Response to Anonymous Referee #2

Response to General Comments

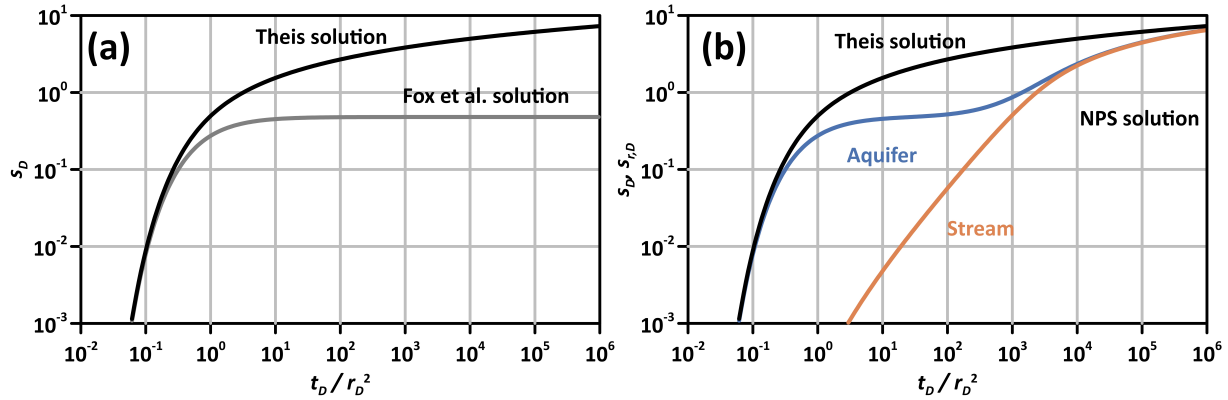
2. The main contribution of the paper is not very clear: is it about an analytical solution, or is it about the implications of a poorly recognized phenomenon? In particular, the authors refer to (Zlotnik, 2004) several times, but without explaining what the difference between (Zlotnik, 2004) work and this work is. Moreover, the authors should clarify that numerical models (at least MODFLOW) do allow for simulating stream stage drawdown induced by pumping. Currently, they almost insinuate the contrary (the introduction is quite unclear about it, up to the point of being misleading).

Response: In this response comment by the reviewer, we strive below and in the revised manuscript, to clarify the main contribution of our work, which was identified explicitly in lines 47 – 51 of the original manuscript. The contribution is about both a new analytical solution and “the implications of a poorly recognized phenomenon,” namely transient stream drawdown and channel storage. Our work differs from that of Zlotnik (2004) in our treatment of the boundary condition at the stream-aquifer interface. Whereas Zlotnik (2004) uses a fixed-stream stage in a leaky aquifer, we allow stream stage to respond to groundwater pumping; whereas Zlotnik (2004), and all models that use the fixed-stage condition, cannot predict transient stream drawdown response to pumping, our model predicts this in addition to stream depletion. The model of Zlotnik (2004) suffers from the same limitation as the other models reviewed in our introduction, namely that they predict stream depletion but not associated stream drawdown response; to reiterate, these models are based on the fixed-stage assumption and as such, stream drawdown is by definition zero. We have developed an analytical solution that overcomes this limitation; we have then apply the solution to a field example. We develop the solution by first modifying the boundary condition at the stream-aquifer interface using a mass balance condition regulated by a finite stream channel storage coefficient. We demonstrate that fixed-stage models coincide with our model in the limit as the stream channel storage coefficient approaches infinity, $C_r \rightarrow \infty$. The numerical model is only used in our work to validate the analytical solution. We state however, that MODFLOW also relies on the same fixed-stage condition used by the earlier analytical models. To make our contribution clearer here in the response, we include Figure 1 where we plot the predicted behavior of the old models (a) separate from the new model (b). The model of Fox et al. (2002) is the general representation of all fixed-stage models for confined aquifer flow including those that account for aquifer leakage such as the model of Zlotnik (2004). To highlight the main contribution our work, the introduction is revised as follows: “Given the limitations of the stream depletion models reviewed above, an alternative theory is proposed here where a new boundary condition is imposed at the stream-aquifer interface by invoking the mass-balance principle and introducing the concept of finite stream channel storage. Hence, in this study, two semi-analytical models are developed for the

Figure 2: The schematic diagram of the conceptual model of the stream-aquifer system used for the (a) non-penetrating stream (NPS) and (b) fully-penetrating stream (FPS) models derived herein.

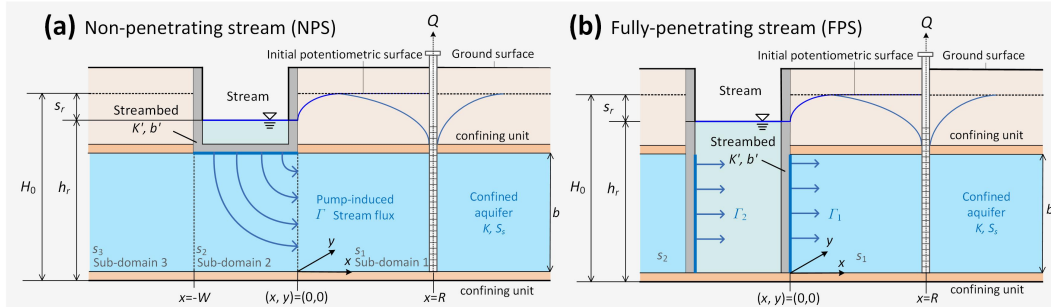
11. L87-88: Where is the origin of the y axis?

Response: *We appreciate your feedback regarding the missing explanation of the origin of the y axis. We have now included the following statement in our description: "The y axis origin is located at the point where the line perpendicular to the pumping well and the stream intersects the closest stream bank." Additionally, we have updated the diagram (see the figure below) to clearly indicate the location of the axis origins.*

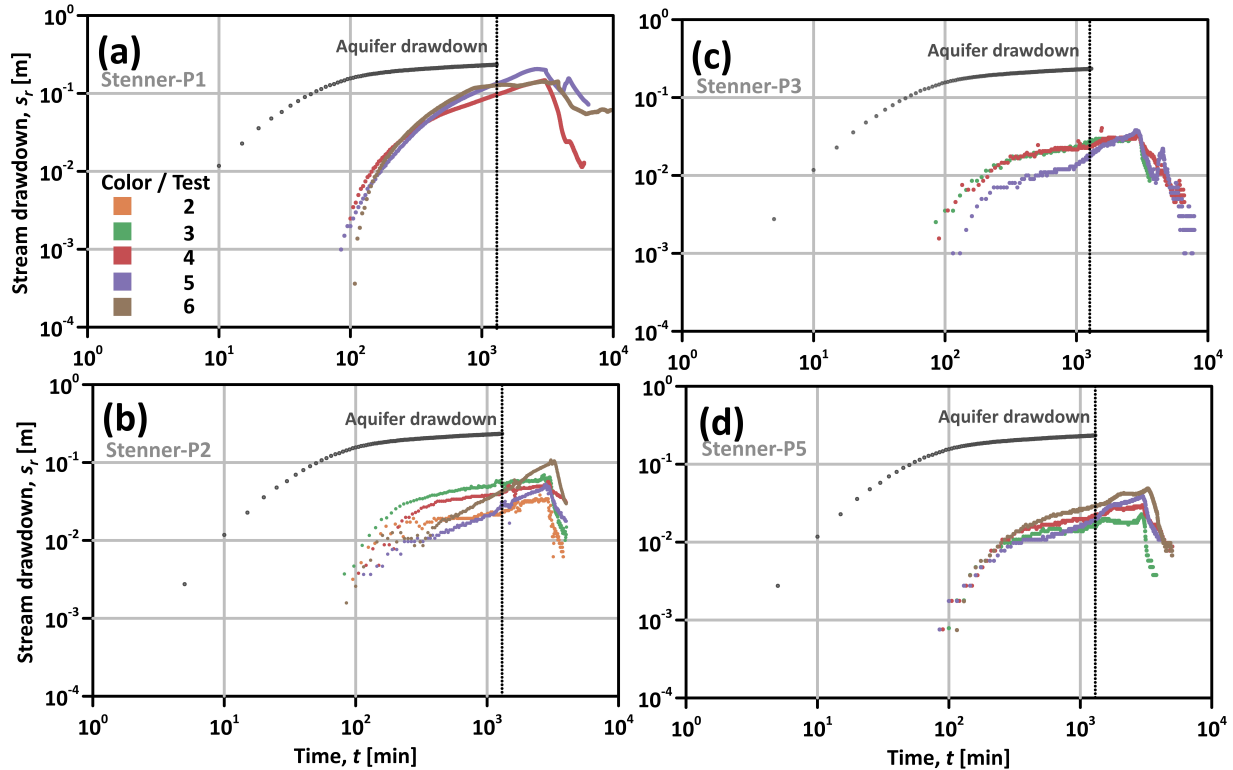
40. L376: Where are the recovery data

Response: *In the revised manuscript, the stream drawdown plots have included data from the recovery period (data collected after pump shutdown.), ensuring completeness. (see the figure below). Only drawdown data (pumping-phase) are analyzed with model fitting and parameter estimation because the recovery-phases were disrupted by follow-up pumping at the study site. The figure showing stream drawdown data with recovery has been updated in the revised manuscript as shown here in Figure 3. Is the reviewer unsure about the meaning of "recovery data"? It could refer to data collected during the recovery period or data that has not been detrended. I think the reviewer is asking about recovery-phase. He/she may be wondering also why no recovery data from the observation well are plotted. We can ignore that. Stream drawdown recovery is sufficient. Great!*
